Revision to an existing permit project BNR25-01347

Scope of Project

Remove existing counterweight rigging system. Cover arbor well stage right. Install mounting steel for rigging / motors. Install 37 prodigy variable speed motors, headblocks and loft blocks. Extend battens 8'. Install new fireproof drapes and scrims.

**City of Kirkland
Post Revision
Reviewed by PJM
07/08/2025**

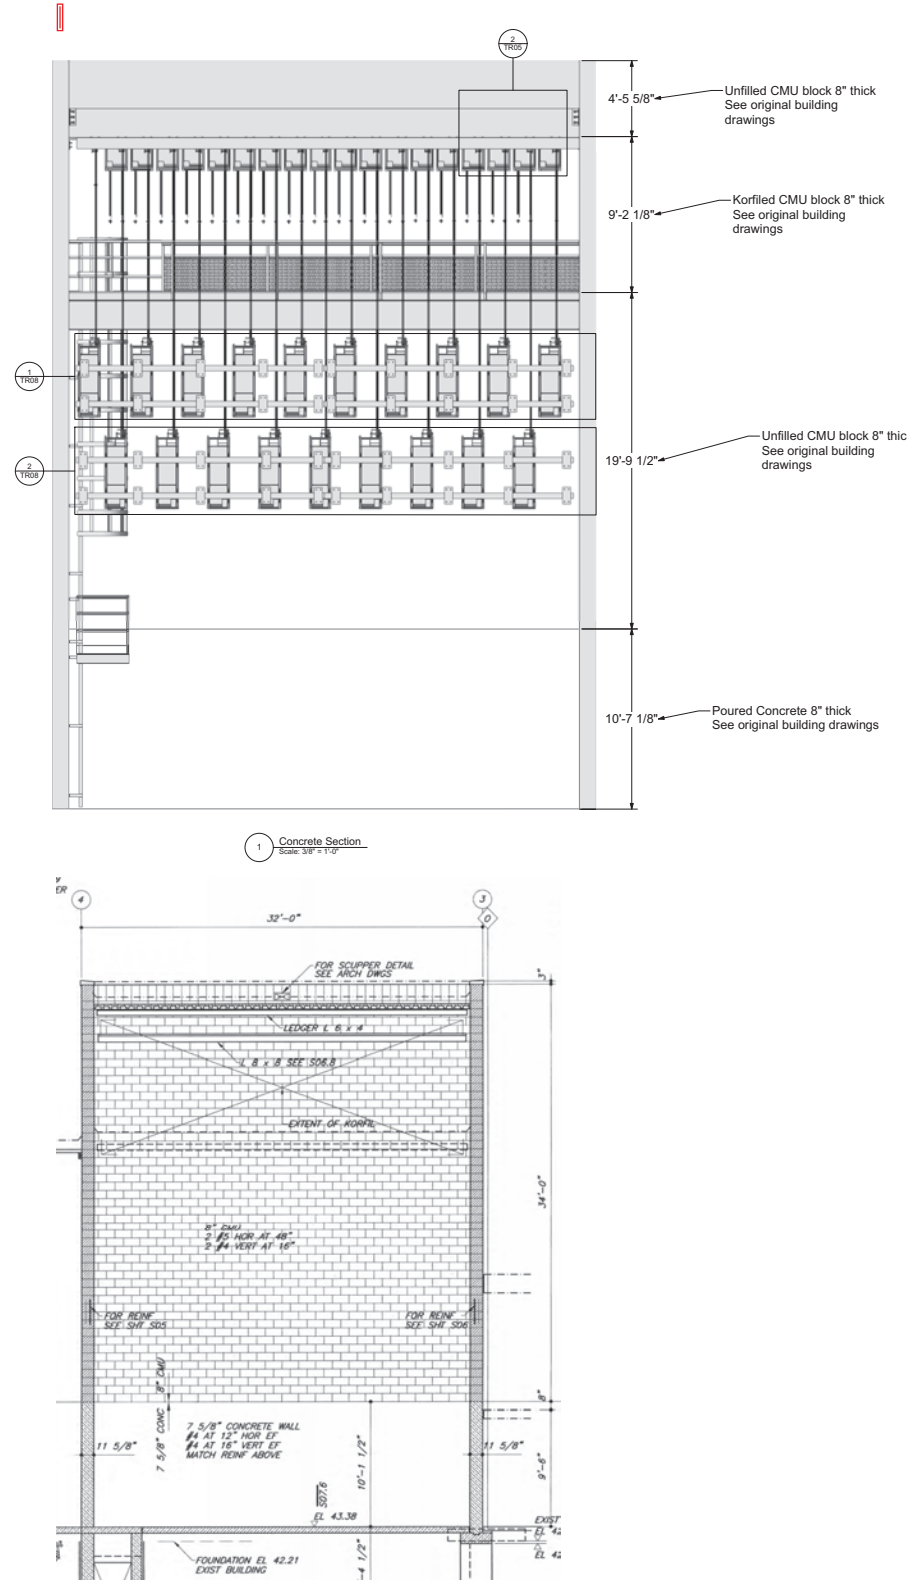
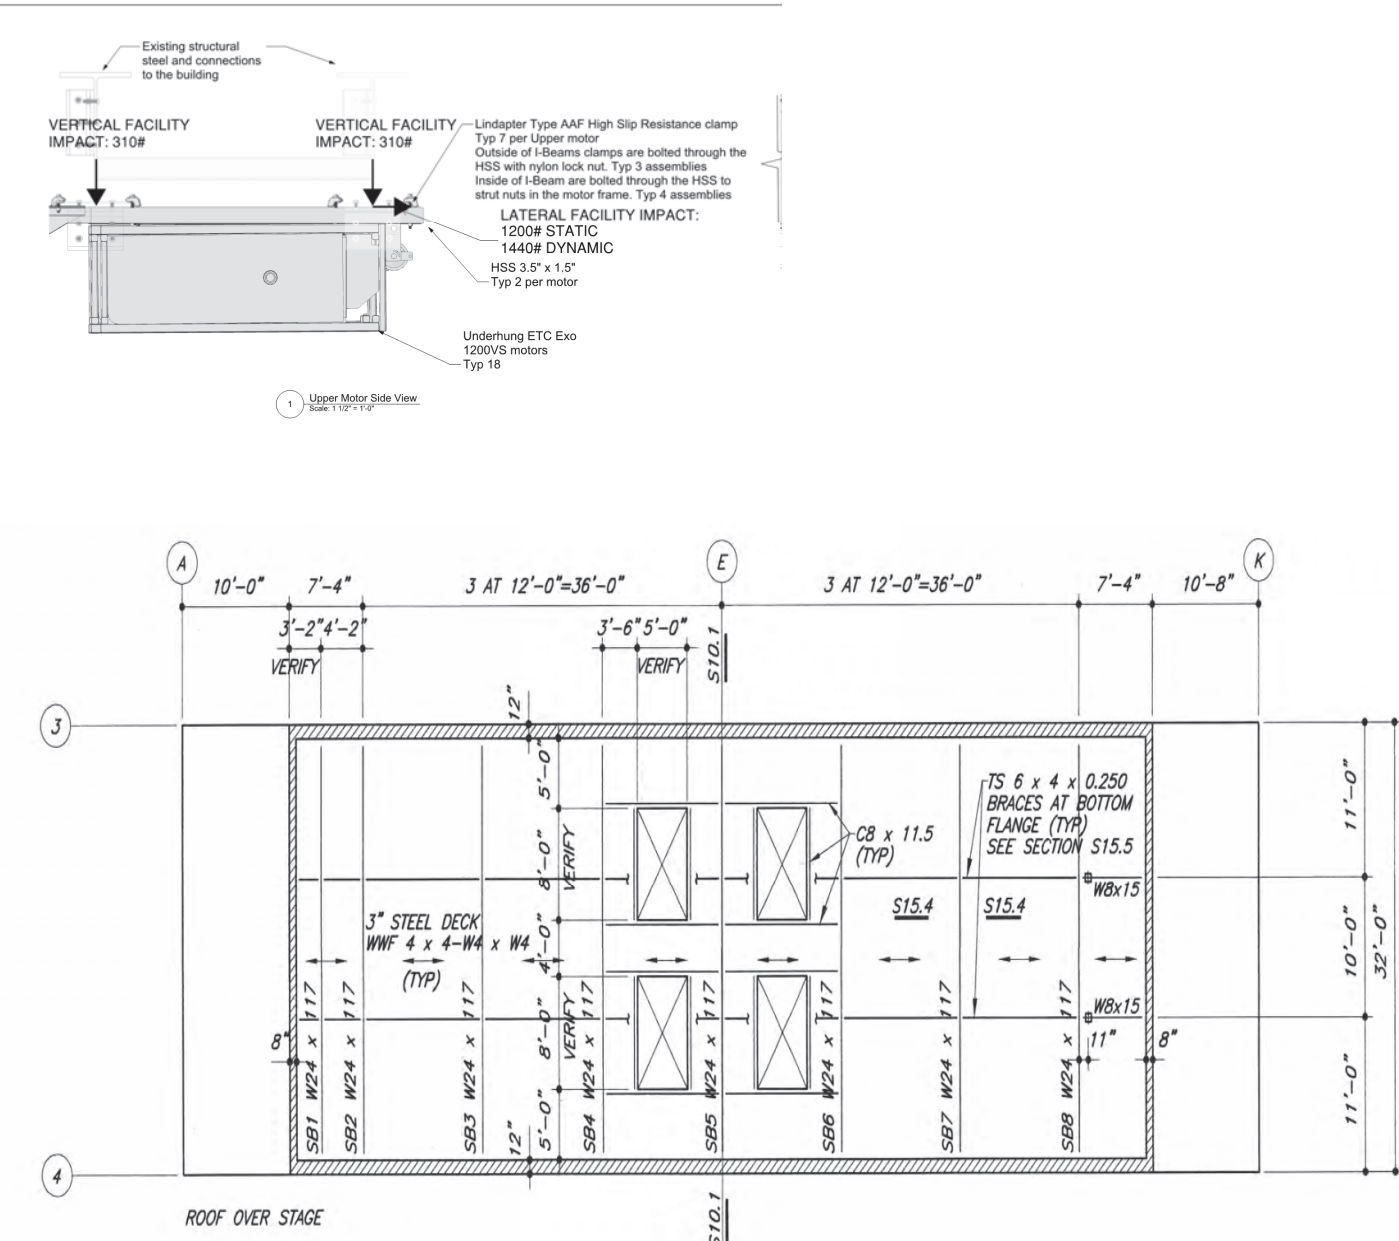
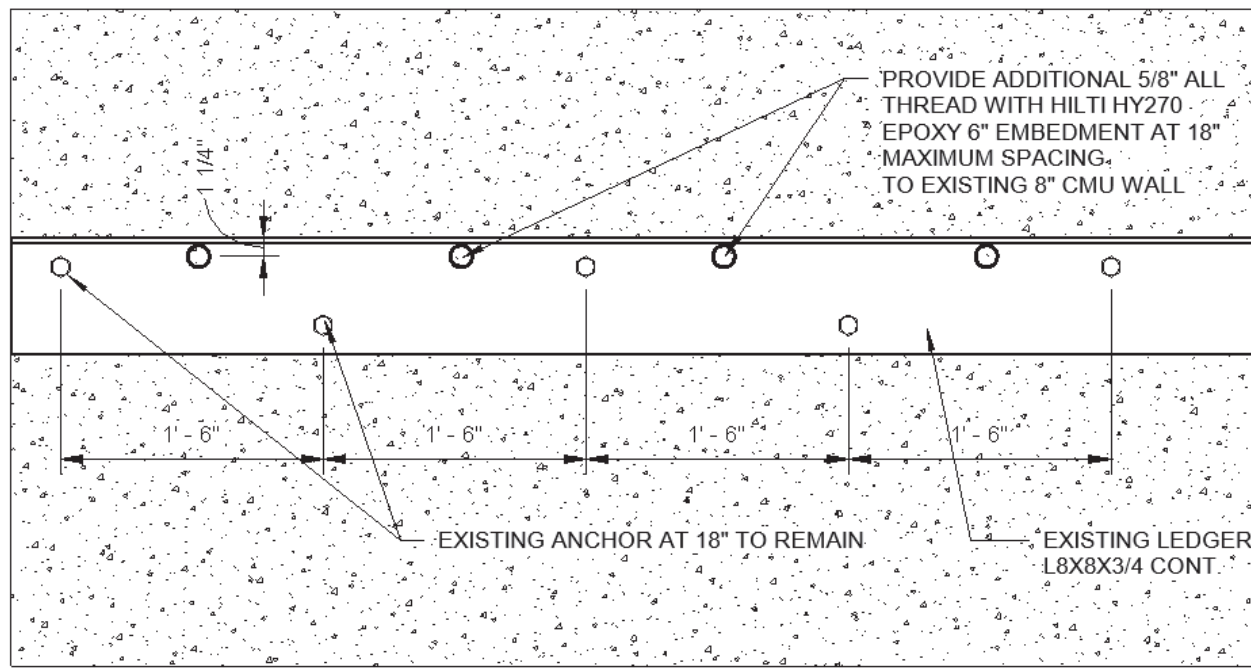
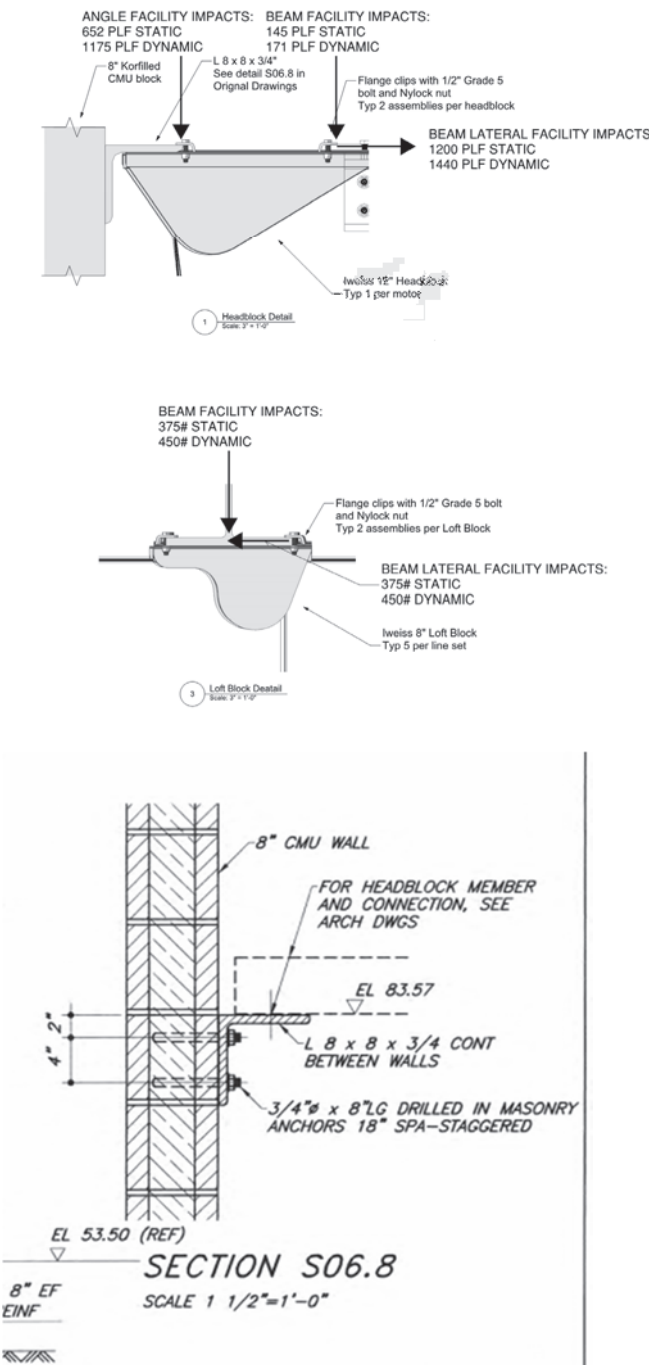
1. CHECK EXISTING REINFORCED CMU WALL FOR ADDITIONAL RIGGING VERTICAL LOAD.
CMU WALL 8 INCH THICK REINFORCED WITH 2-#4 VERTICAL AT 16"
THE WALL DOES NOT CARRY MUCH GRAVITY LOAD

RIGGING FORCE PER FT WIDTH OF CMU = 572 PLF
PLEASE SEE ATTACHED SPREADSHEET CALCULATION, THE CMU WALL IS ADEQUATE TO RESIST RIGGING FORCE COMBINED WITH INTERIOR WIND PRESSURE OR WALL SEISMIC LOAD.

2. CHECK (2) RIGGING BEAMS W24X117 CLOSER TO GRID-A TO SUPPORT VERTICAL AND LATERAL LOAD:
VERTICAL IMPACT LOAD = 310 LBS AT EACH MOTOR AT EACH BEAM
HORIZONTAL IMPACT LOAD = 1440 LBS AT EACH BEAM
TOTAL VERTICAL IMPACT LOAD ON EACH BEAM = 18 X 310 = 5580 LBS
HORIZONTAL IMPACT LOAD ON EACH BEAM = 1440/2 * 12"/18" = 480 PLF
BEAM DEAD LOAD = 150 PSF X 7 FT = 1050 PLF
BEAM LIVE LOAD = 100 PSF X 7 FT = 700 PLF
FOR GRAVITY LOAD, W24X117 IS ADEQUATE BY MORE THAN 172 PERCENT.

FOR TORSION DUE TO HORIZONTAL IMPACT LOAD THE BEAM STRESS RATIO IS LESS THAN 0.4 < 1.0 OK
PLS SEE ATTACHED CALCULATIONS

3. CHECK STEEL ANGLE AND ANCHORAGE TO SUPPORT RIGGING IMPACT FORCES

VERTICAL IMPACT LOAD = 1175 PLF
MOMENT = 1175 x 8 '' = 9400 LB-IN = 9.4 K-IN
CHECK L8X8X3/4 CONTINUOUS ANGLE
ALLOWABLE MOMENT = F_y * Z/1.67 = 36 KSI * 12'' X 0.75 ^2/(4 * 1.67) = 36.4 K-IN (OK)
EXISTING ANCHORS SPACED AT 18 INCH IS NOT ADEQUATE. INSTALL ADDITIONAL HILTI 5/8" ALL THREAD (A36) AT 18" AT THE TOP OF THE ANGLE (USING HY270 ADHESIVE). PLS SEE ATTACHED DETAIL AND CALCULATIONS. IT IS MORE CONSERVATIVE SINCE THE CMU WALL MAYBE HOLLOW AT THIS LOCATION.

ADDITIONAL EPOXY ANCHORS AT STEEL LEDGER
